***3 Volt Intel[®] Advanced Boot
Block Flash Memory
28F004/400/008/800/
016/160/320/640B3 (x8/x16)***

Specification Update

April 2002

Order Number: 297948-012

2. Invalid Read Durations for CE# High Pulse Width

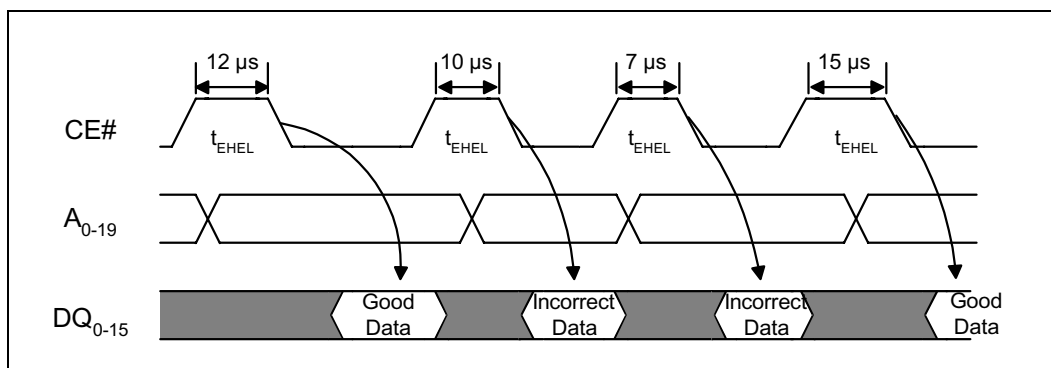
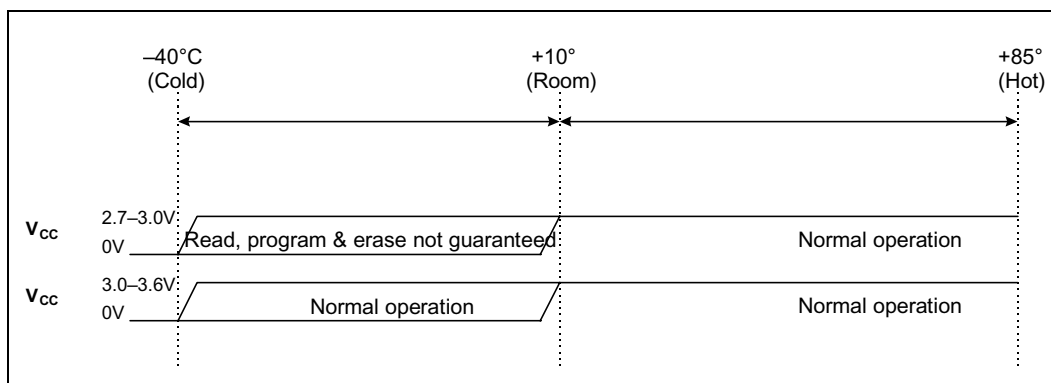
Problem: During consecutive read operations, CE# may be left low or toggled as desired. If CE# is toggled high (see diagram below) for 4 μ s–11 μ s between read operations, subsequent reads will return incorrect data.

Implication: If CE# is not toggled between consecutive reads, there is no impact. Any application that toggles CE# between read operations will be affected if the CE# high pulse width is within the nonfunctional range, i.e., 4 μ s $\leq t_{\text{EHEL}} \leq 11$ μ s.

Workaround: Either of the following actions will prevent this erratum:

1. Do not toggle CE# between consecutive read operations
2. Insure t_{EHEL} is less than 4 ms or greater than 11 μ s

5. Maximum I_{CCD} Change

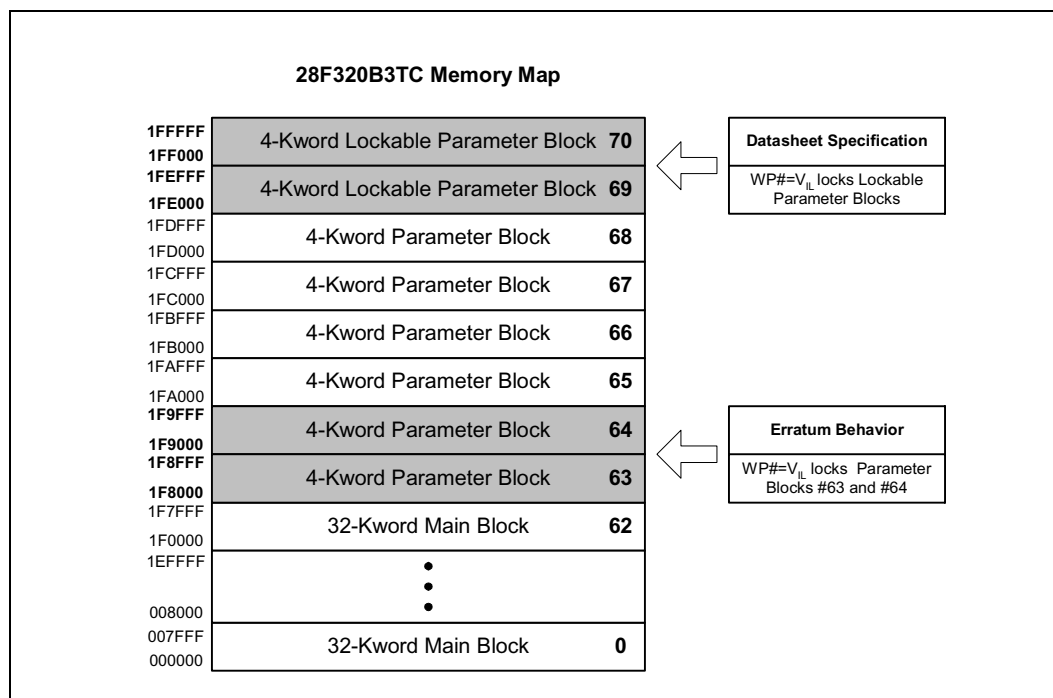
Problem: The maximum I_{CCD} increases from 20 μ A to 25 μ A. The following in the revised I_{CCD} specification:

Implication: The maximum I_{CCD} is specified under worst case conditions only ($V_{CC} = 3.6$ V, temperature = +85 °C). The typical I_{CCD} specification should be used to determine I_{CCD} current draw under typical conditions ($V_{CC} = 3.3$ V, temperature = +25 °C). The typical I_{CCD} specification has not changed.

7. 28F320B3xC Reset Failure

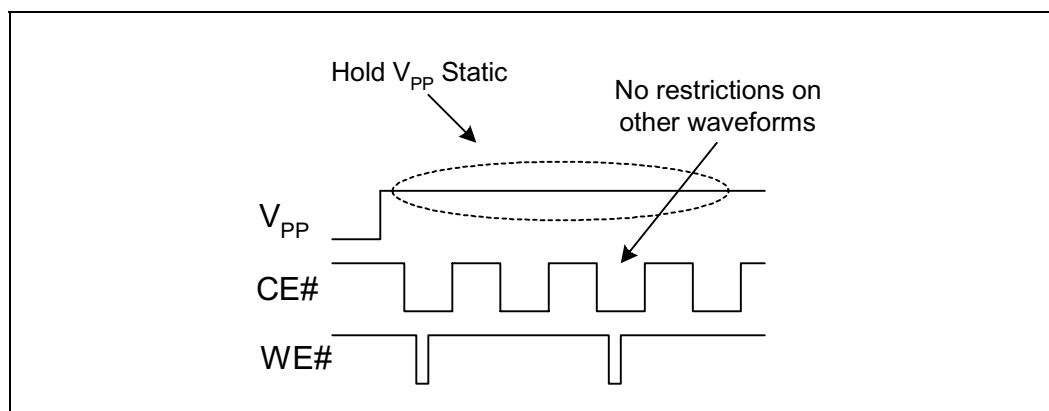
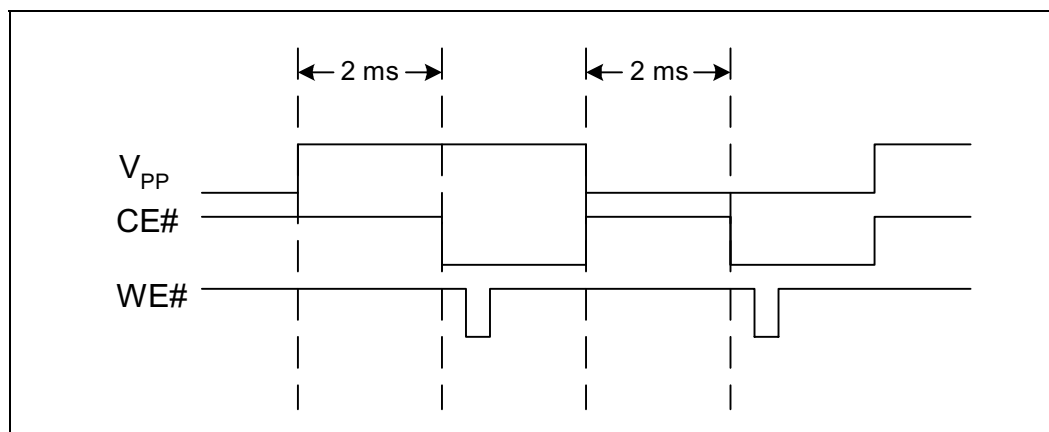
Problem: The 0.18 μ m 28F320B3xC devices can unintentionally reset under certain conditions where V_{PP} toggles.

Implication: When the reset occurs, any command being executed is interrupted and the flash switches to read array mode.

Workaround: There are four workarounds for this erratum:

1) Tie V_{PP} to V_{CC}

2) If the third and forth digits on the top side FPO mark (third line) are equal or greater than “23”, then V_{CC} may be set from 2.7 V to 3.3 V. V_{CC} must not exceed 3.3 V.

3) Set V_{PP} to a static high or static low level as shown here; and

4) Wait 2 ms after a V_{PP} transition to access the flash device as shown here.

Figure 1. Workaround Placement

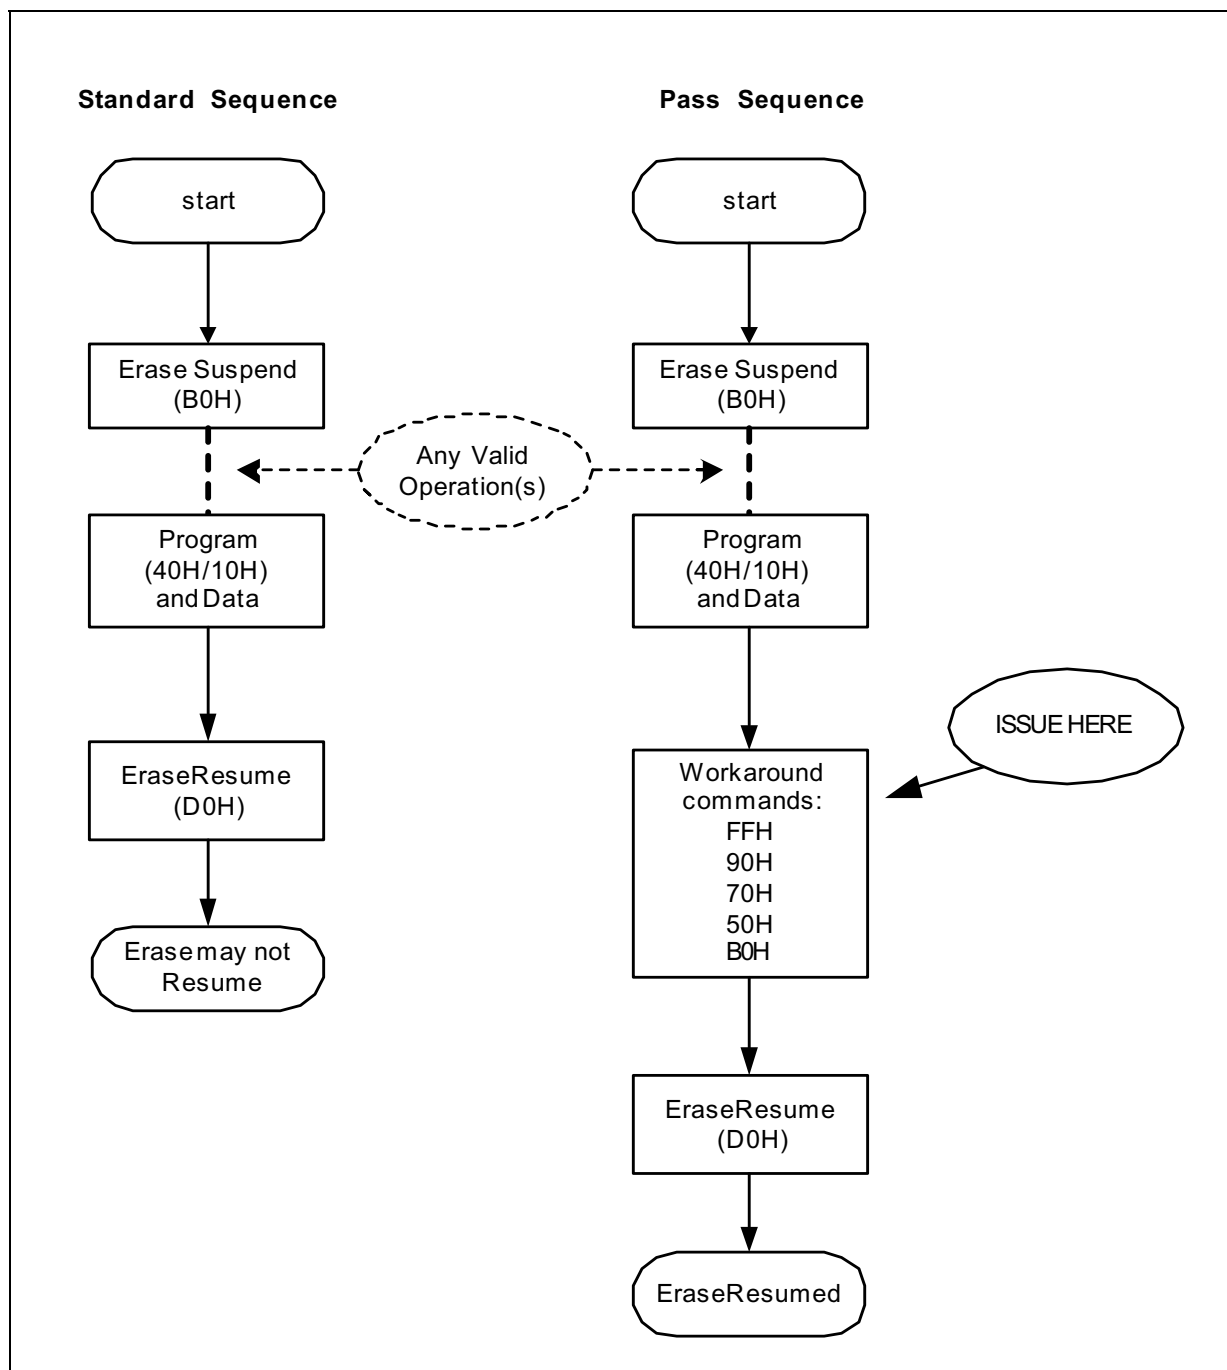
Problem: On the 0.18μm 28F160B3xC device, a design anomaly was discovered. During an Erase-Suspend operation, if the Program (40H/10H) sequence is executed, under limited conditions the proceeding Erase Resume command (D0H) may not actually resume the device. No customers have reported failures in product applications. Customers who use any version of FDI (Intel Flash Data Integrator) software will not see this issue. If the Read Array command is issued prior to the Erase Resume command, users will not see the issue (typical in XIP applications).

Implication: The Resume Command (D0H) may be ignored by the device and will not correctly resume. The device will appear to remain in suspend (via status register). After a reset of the flash device the status register will clear. This failure has been recreated in a lab environment only.

Workaround: There are 2 workarounds for this erratum.

1. If FDI (Intel Flash Data Integrator) software is used, users will not see the issue.
2. During an Erase-Suspend (B0H), user must issue any of the following commands listed in Table-1 after issuing the Program (40H/10H) and data sequence but before issuing the Erase-Resume (D0H) command.
